WATTS BAR NUCLEAR PLANT (WBN) UNITS 1 AND 2  
STATION BLACKOUT  
SUPPLEMENTAL INFORMATION

The following questions and responses were informally discussed between NRC and TVA in a teleconference conducted on November 19, 1992. These questions resulted from NRC's review of TVA's Station Blackout (SBO) submittal dated August 31, 1992. The enclosure and page numbers referenced below are from that August 31, 1992 submittal.

# 125 VDC VITAL BATTERY LOAD PROFILE

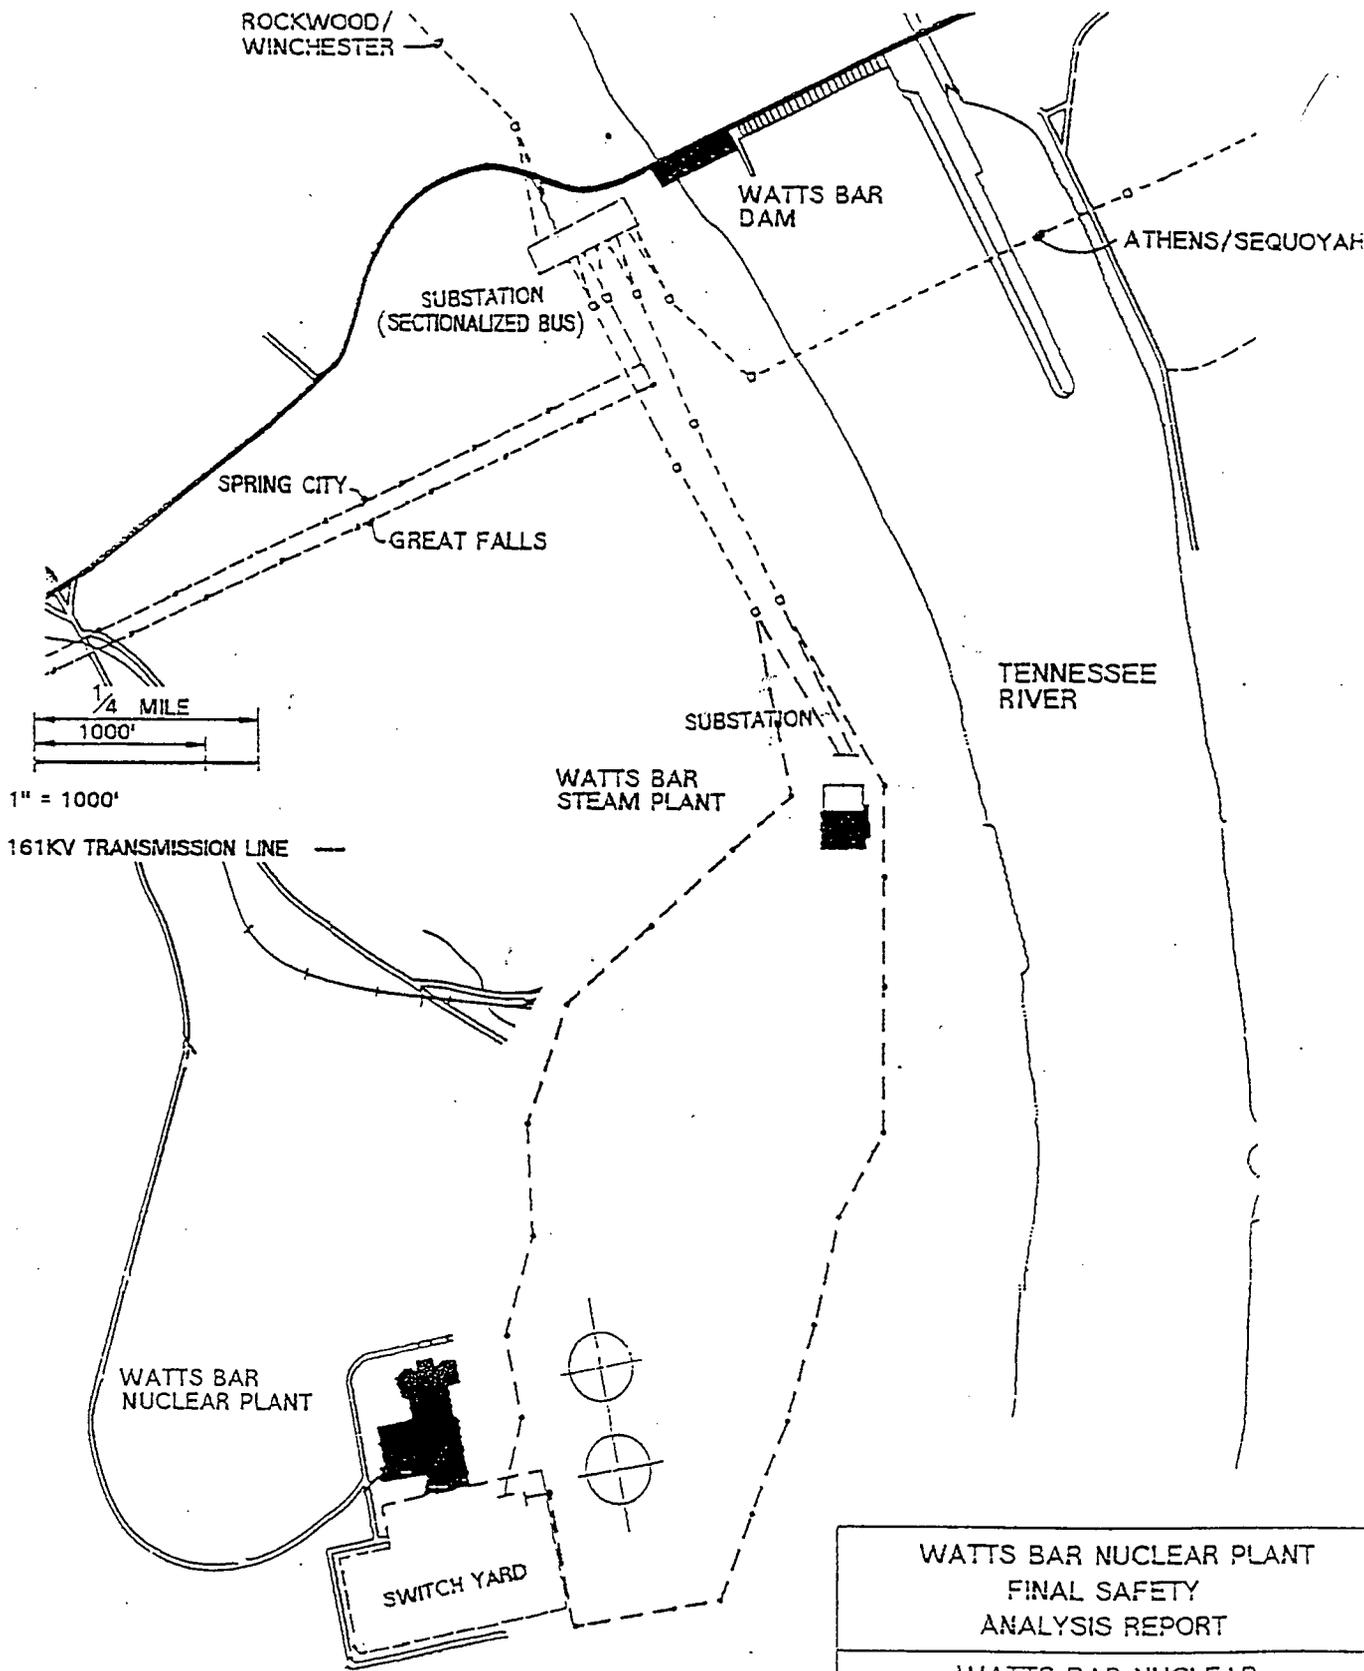
NRC Question (Page 20)

The submittal indicates the temperature correction and aging factors used in the battery calculations but does not indicate the margin. Provide the margins for the vital batteries.

105V dc. This minimum voltage was used conservatively to calculate the load on the batteries. TVA has investigated breaking this third step into smaller time intervals to more realistically match the expected voltage for a particular interval and, thus, to better estimate the demand on the battery.

The currents calculated by this worst-case investigation, using the expected average voltage levels, are shown in Exhibit 2. From these results, the number of positive plates required based on the IEEE-485 worksheet is 13.97. Applying the following formula: cells actual minus the cells required divided by cells actual (or  $15.0 - 13.97/15.0$ ), a design margin of approximately 6.9 percent can be demonstrated.

The results of this investigation demonstrate that margins comparable to that suggested in IEEE-485 for sizing batteries does exist for the anticipated battery loading during an SBO event. TVA does not currently plan to revise the calculation of record to explicitly take credit for this margin. Based on this demonstration, it can be seen that the batteries at WBN do have adequate margins to accommodate a limited number of unexpected load perturbations during an SBO event. Some assurance of this capability is believed to be NRC's concern regarding margin, and the implicit margin provided in the WBN calculation should adequately resolve this concern.
